ALERT SERVICE BULLETIN

205-23-120

MODEL AFFECTED: 205A/205A-1

SUBJECT: TENSION ROD ASSEMBLY P/N 205-030-249-009 OR 205-030-249-013, INSPECTION OF.

LOOKING OUTBOARD ON LOWER ATTACHMENT
Figure 5. Rework requirements

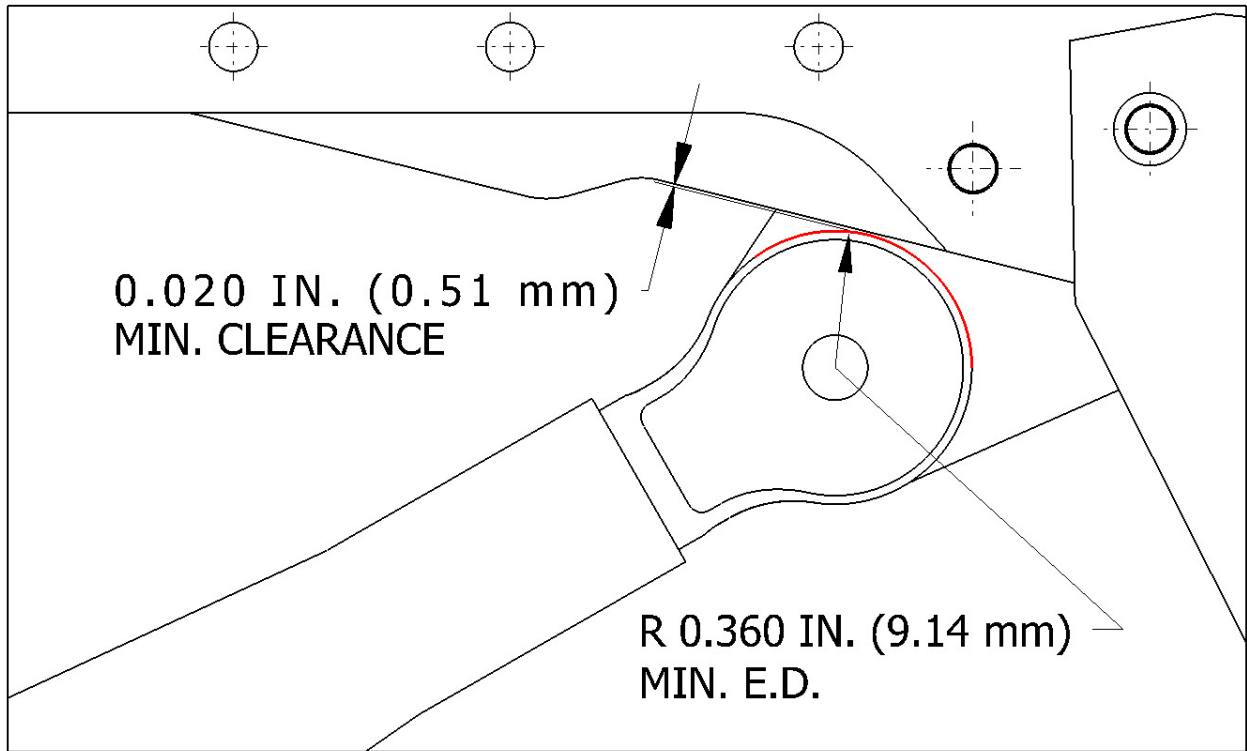
It is acceptable to remove material from the rod ends and/or the structure attachment fittings provided the inspection criteria defined in **PART I** are respected (Figures 4,5 and 6).

4. Remove the tension rod assembly (step 1.a.).
5. Trim and deburr previously marked material on the affected rod end and/or structure attachment fitting. Ensure the inspection criteria defined in **PART I** are respected (Figures 4,5 and 6).
6. Apply chemical film (C-100) and one coat of epoxy polyamide primer (C-204) to reworked area.
7. Install the tension rod assembly (step 2.a.).
8. Make an entry in the helicopter logbook and historical service records indicating compliance with this Alert Service Bulletin.

Figure 1. Inspection requirements

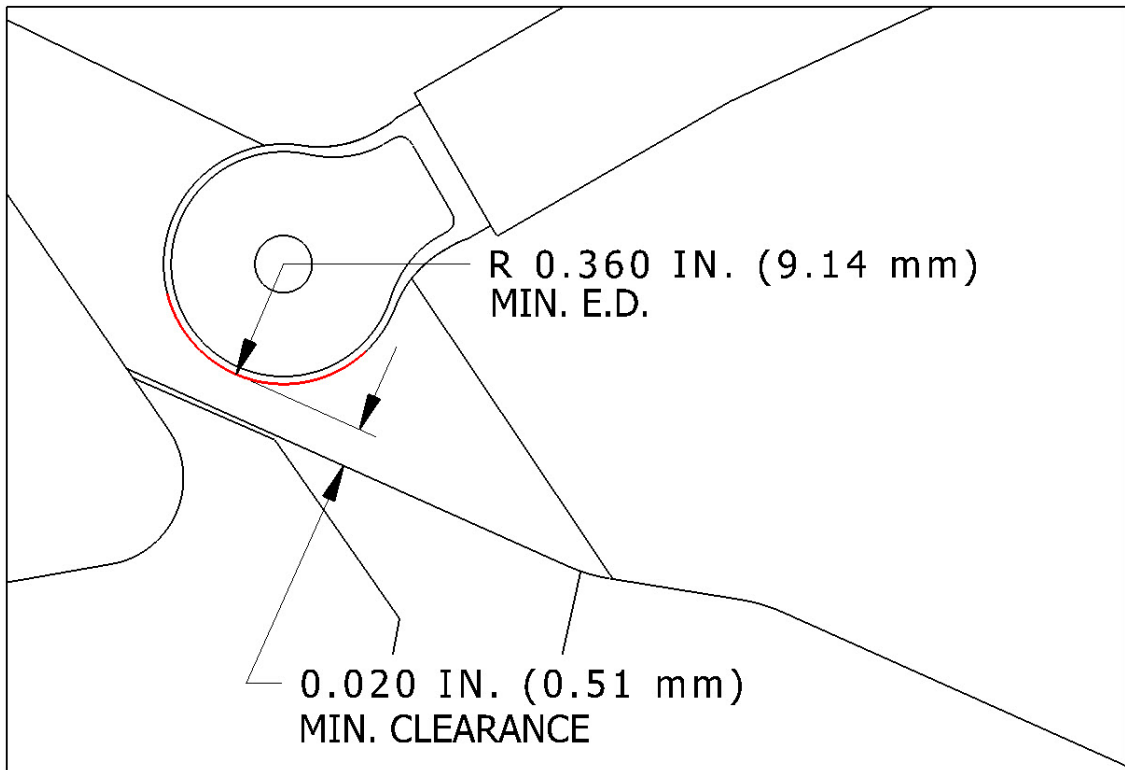
2. Inspect the forward end (upper attachment location) of the tension rod assembly as follows:
 - a. Inspect the outboard side of the tension rod assembly rod end for a possible over trimmed condition. Minimum acceptable radius dimension measured from the bolt hole center is 0.360 inch (9.14 mm) edge distance (E.D.) (Figure 1). Removal of the attachment bolt may be required to perform this measurement. Record findings.
 - b. Check for fouling or low clearance conditions between the rod end and the structure (cap, web, angle). Minimum acceptable clearance is 0.020 inch (0.51 mm) (Figure 1). Record findings.
3. Inspect the aft end (lower attachment location) of the tension rod assembly as follows:

4. Following the inspections performed in steps 2 and 3, accomplish one of the following actions:
- a. If no over trimmed conditions were found and there are no low clearance or fouling conditions, make an entry in the helicopter logbook and historical service records indicating findings and compliance with this Alert Service Bulletin.

- b. If one or both rod ends have been over trimmed, contact Bell Product Support Engineering.
 - c. If no over trim conditions were found but there is a fouling or a low clearance condition, accomplish **PART II**.

Figure 2. Inspection requirements

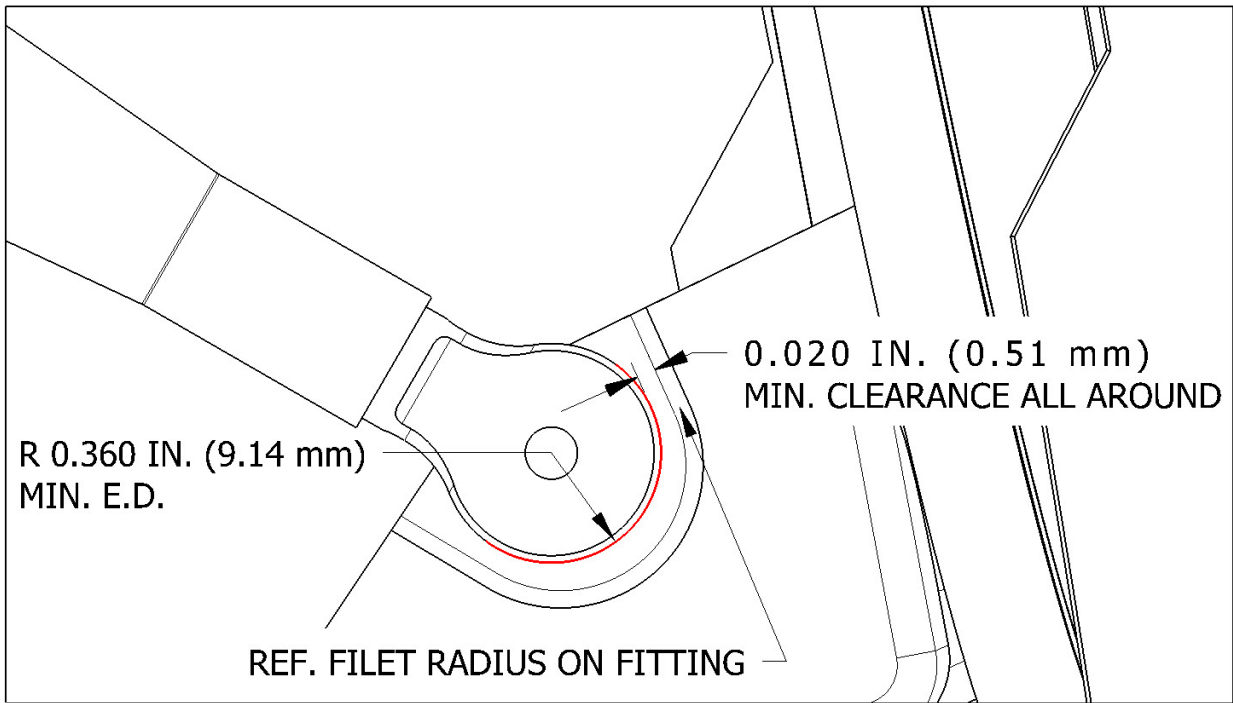
- a. Inspect both sides of the tension rod assembly rod end for a possible over trimmed condition. Minimum acceptable radius dimension measured from the bolt hole center is 0.360 inch (9.14 mm) edge distance (E.D.) (Figure 2 and 3). Removal of the attachment bolt may be required to perform this measurement. Record findings.

- b. Check for fouling or low clearance conditions between the rod end and the structure (cap, web) on the outboard side and the fillet radius on the inboard side of the fitting. Minimum acceptable clearance is 0.020 inch (0.51 mm) (Figures 2 and 3). Record findings.

Figure 6. Rework requirements

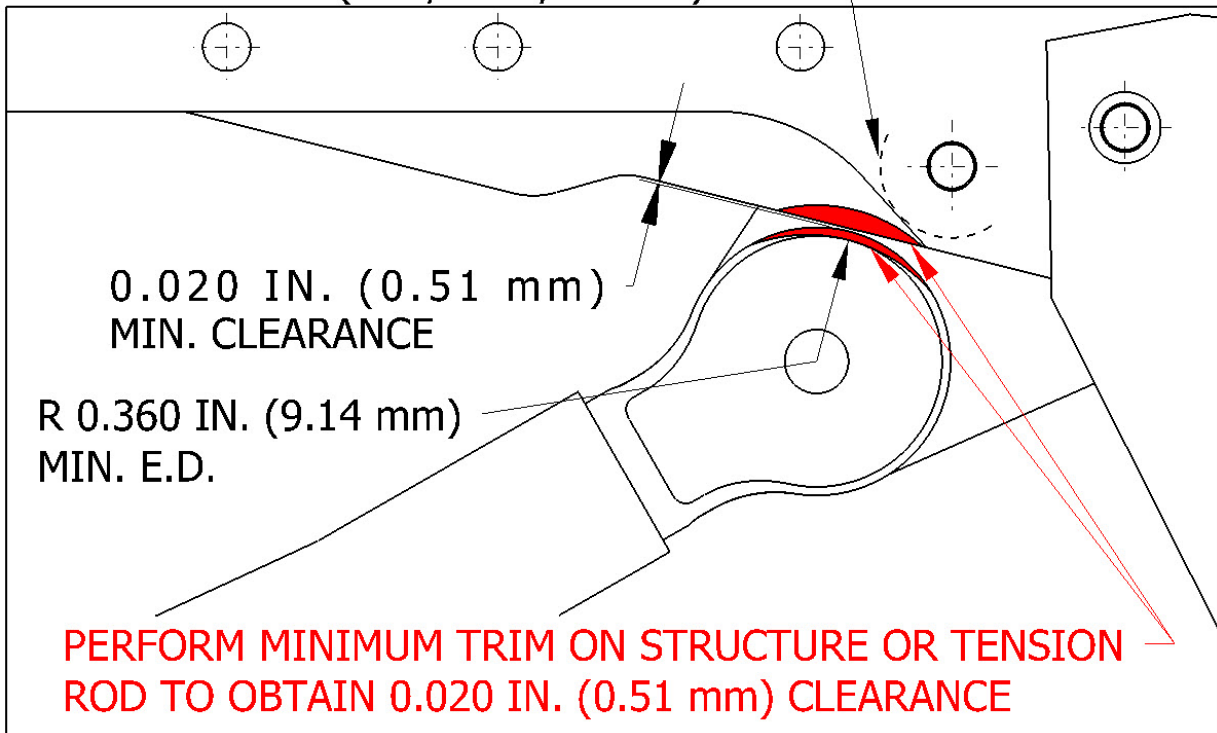
KEEP 0.280 IN. (7.11 mm) MIN. E.D.
FOR FASTENERS (CAP, WEB, ANGLE)

Figure 7. Tension rod assembly proper installation verification

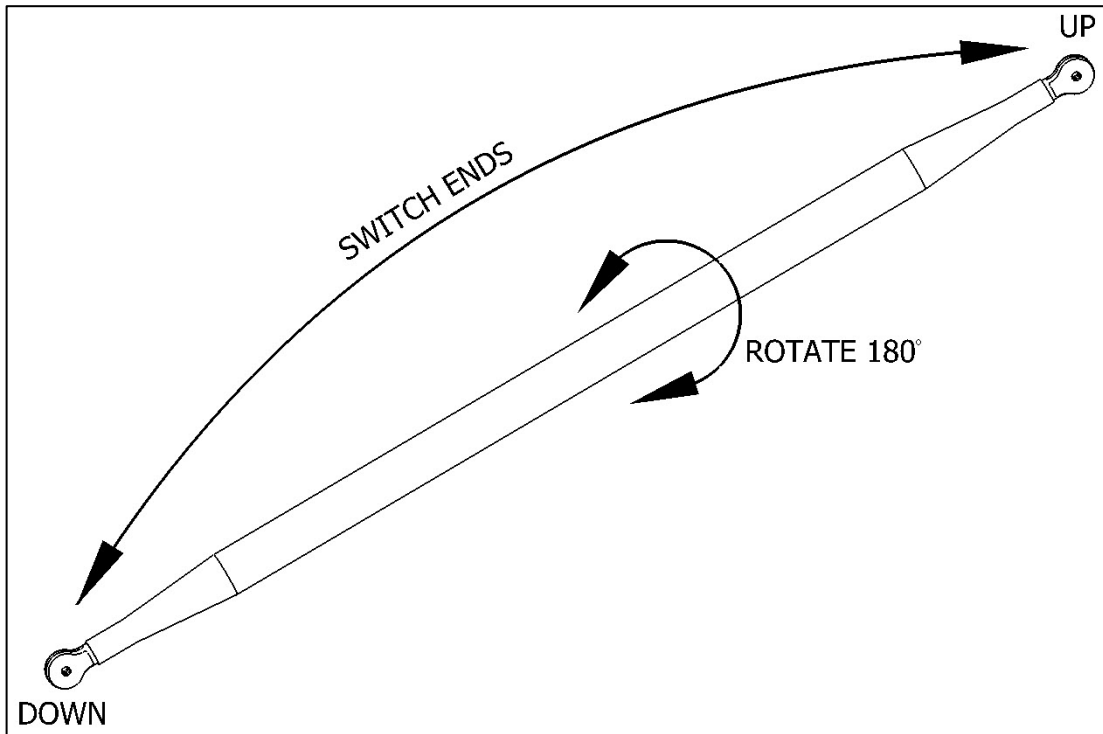
1. If a fouling or a low clearance condition exists, the tension rod assembly may have been installed incorrectly. Prior to trimming the rod ends, remove the tension rod assembly (step 1.a.) and try different orientations by rotating and/or switching ends to obtain the best possible fit (Figure 7). If proper clearance dimensions as defined in **PART I** cannot be met, proceed with step 3.
 - a. Removal of tension rod assembly:
 - (1) Remove the nut, bolt, and washers from the aft end of the tension rod assembly.
 - (2) Remove the nut, bolt, washers, and tension rod assembly from the bulkhead attachment point.
2. If it is established that the root cause of the fouling or low clearance condition is the incorrect installation of the tension rod assembly, reinstall correctly and proceed with step 8.
